Product Change Notice (PCN)

PCN Number: PCN-0451201R-02

Product(s) Affected: PJ-056

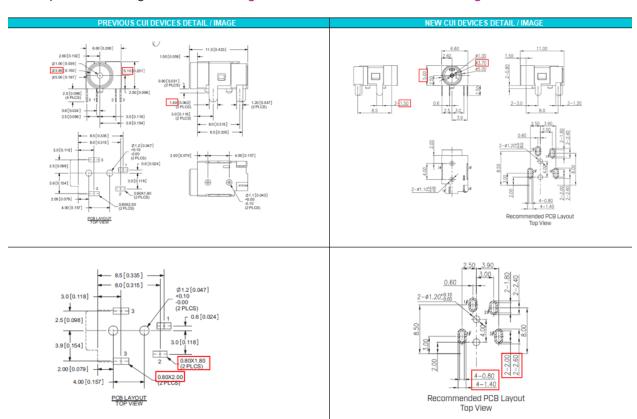
Description of Change: Minor Housing and Material Difference. See image Below

PREVIOUS CUI DEVICES DETAIL / IMAGE NEW CUI DEVICES DETAIL / IMAGE MATERIAL PLATING brass center pin tin DESCRIPTION MATERIAL PLATING/COLOR terminal 1 brass terminal 1 brass tin terminal 2 copper alloy terminal 2 copper alloy tin terminal 3 copper alloy terminal 3 copper alloy tin plastic PA66 PBT (UL94V-0) housing black
